Change Notice Number: 239599

DWG TYPE		PART DRAWING		DELPHI FRAMING SYSTEMS WARREN, OK	
TITLE		DATE			
VOLUME (CWP)		DISTR CODE		28A996	
ROUTING		D		28A996	
6901				28A996	
				28SE96	
UNLESS OTHERWISE SPECIFIED					
THIS DOCUMENT IS IN ACCORDANCE WITH ASME Y14.5M-1994 AS AMENDED BY THE 2003 GLOBAL DIMENSIONING AND COORDINATING ADDENDUM (2003) AND ALL GEOMETRIC TOLERANCES AND RELATED OUTLINE AREFS ARE TO BE FOLLOWED FOR ALL DIMENSIONS UNLESS OTHERWISE SPECIFIED. THE FOLLOWING DIMENSIONING FEATURES IS ESTABLISHED BY ORIENTATION OR LOCATION TOLERANCES. SEPARATE POSITION CALCULATIONS MAY BE OBTAINED SEPARATELY, REGARDLESS OF DATUM REFERENCE.					
ALL DIMENSIONS ARE IN MILLIMETERS					
REFERENCE		DRAWING NAME			
		CONN 2M M/P 280 P25			
THIRD ANGLE PROJECTION		DO NOT SCALE		DRAWING NUMBER	
USE MATR DATA		3/16 UNGRAPICS		12186799	
				SIZE	
				12186799	
				FRAME NO	
				1 OF 2

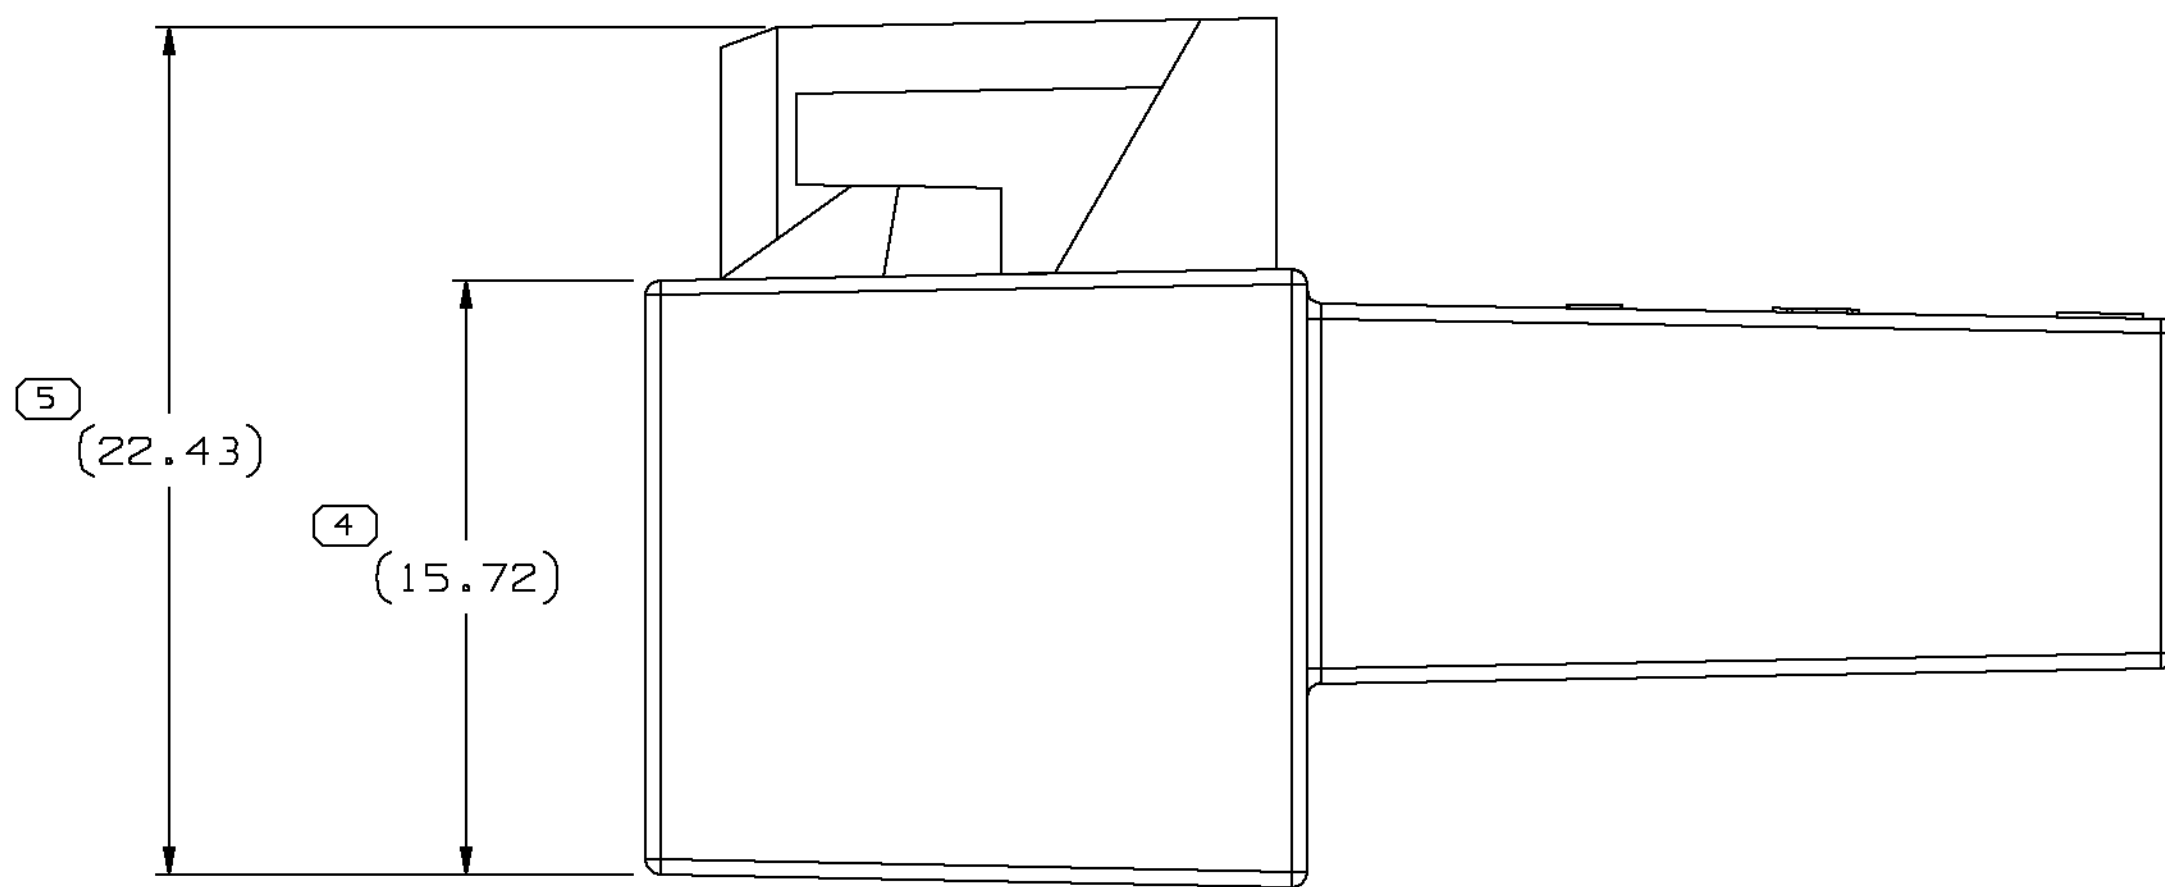
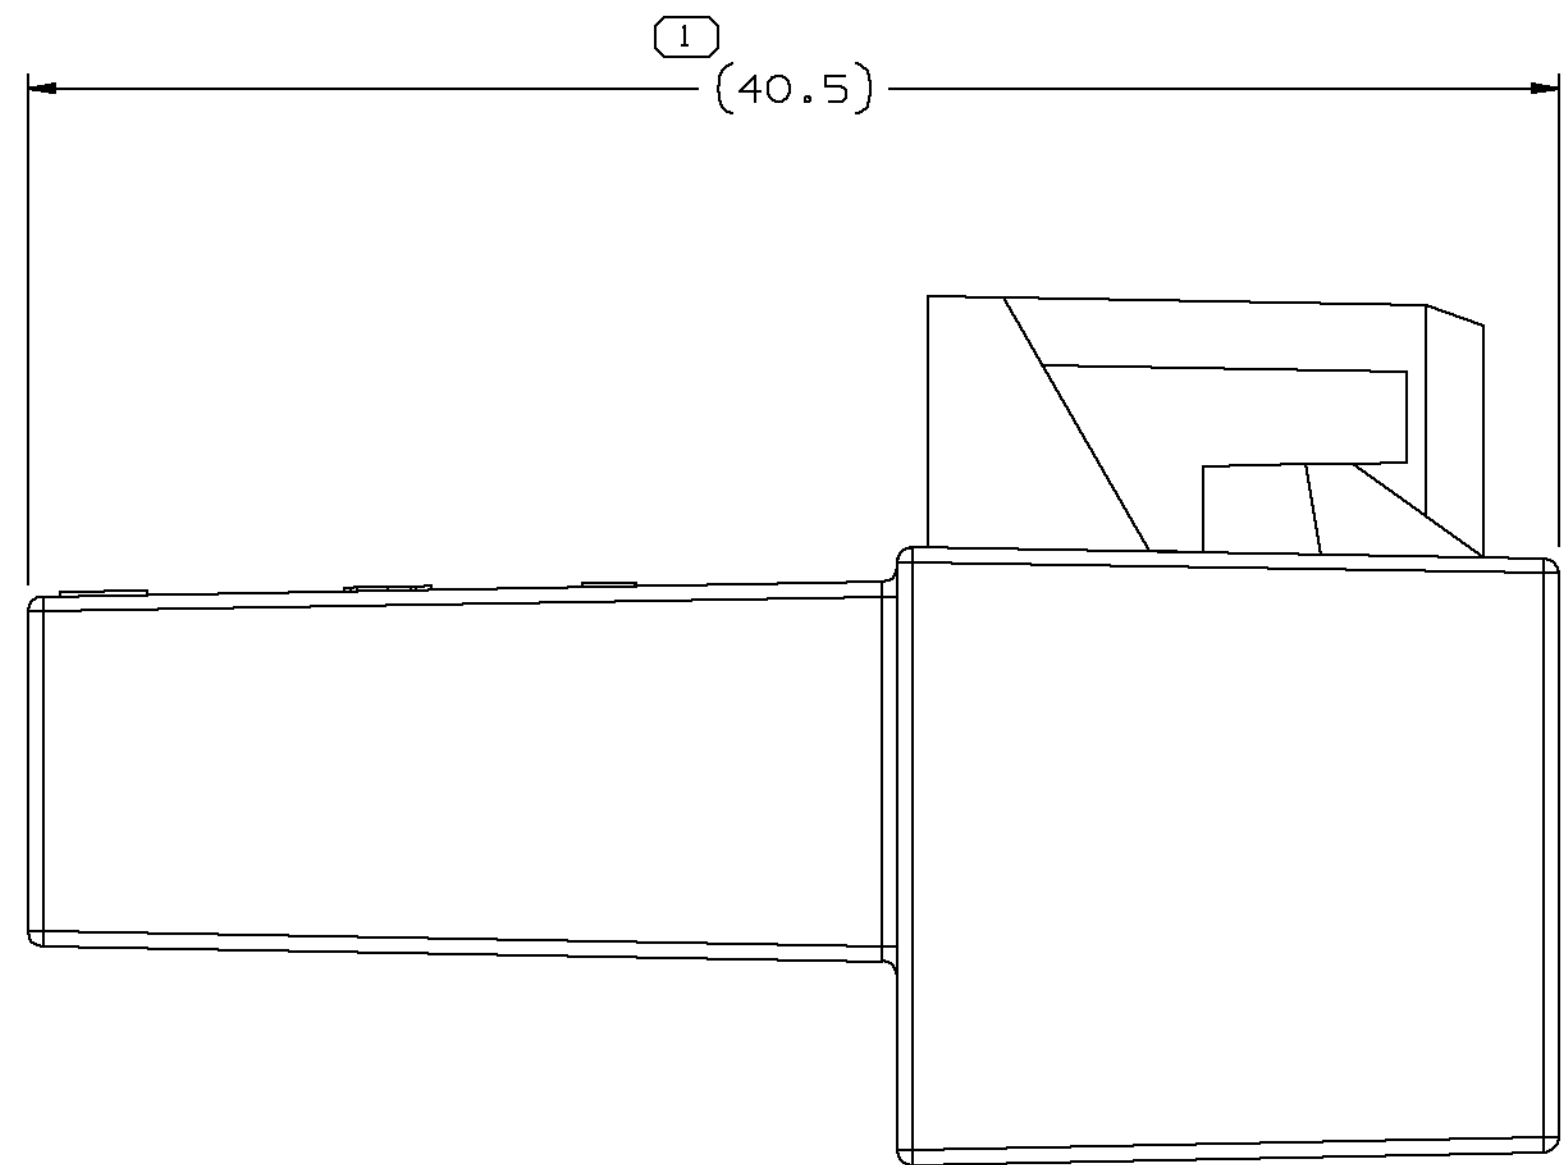
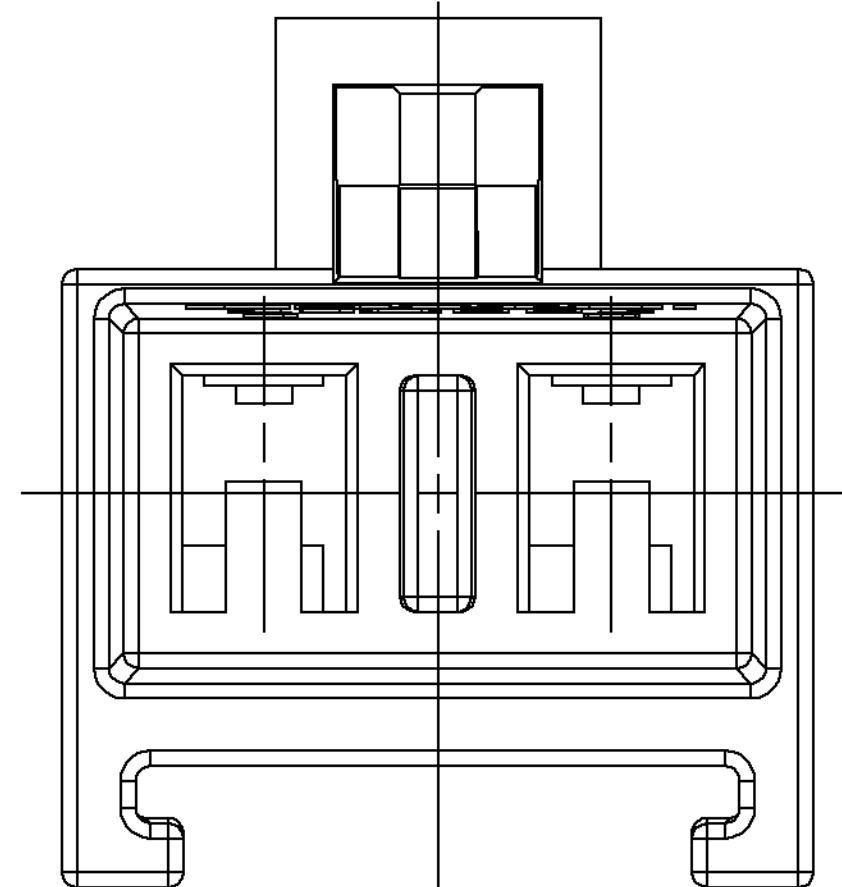
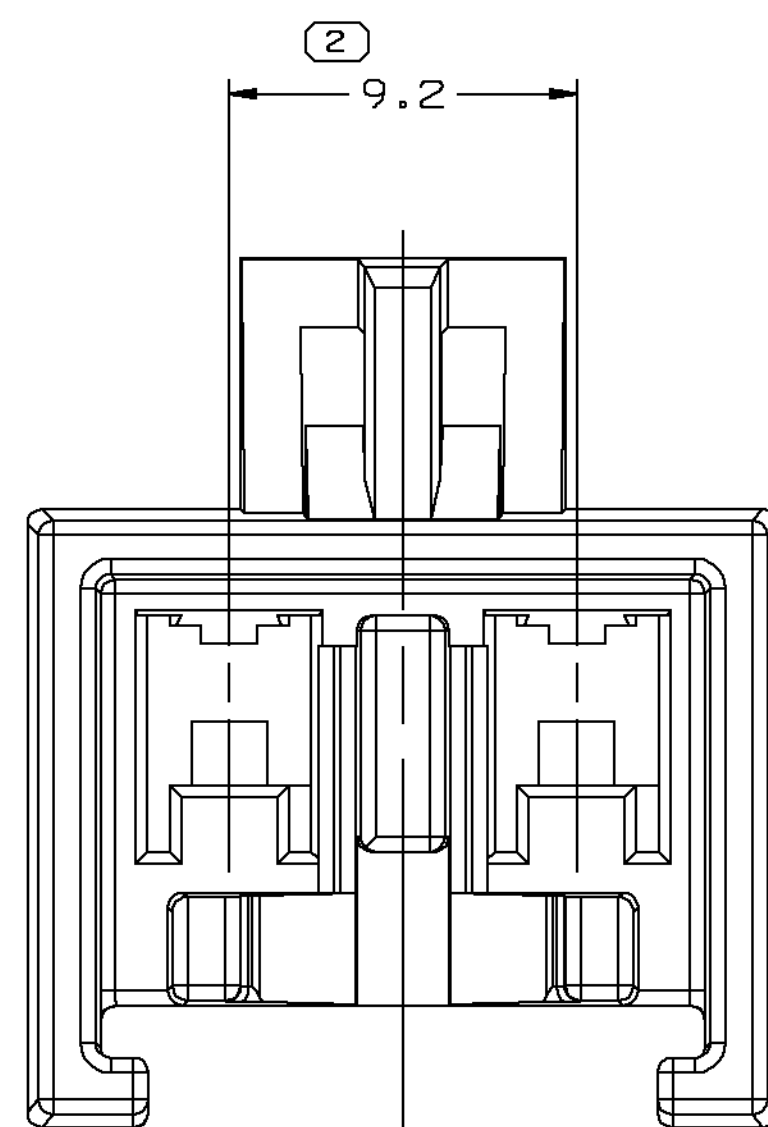
4/8/3 A2 RELAX TOLERANCES FOR:
 Dim # 204 to 4.5 +0.15/-0.20
 Dim # 255 to 16 +0.15/-0.20
 Dim # 256 to 13.8 +0.10/-0.20
 Dim # 266 to 9.45 +0.15/-0.25
 Dim # 288 to 2 +0.15/-0.20
 CORRECT PLACES FOR:
 DIM#216 & 217 FROM 6X TO 4X 239599
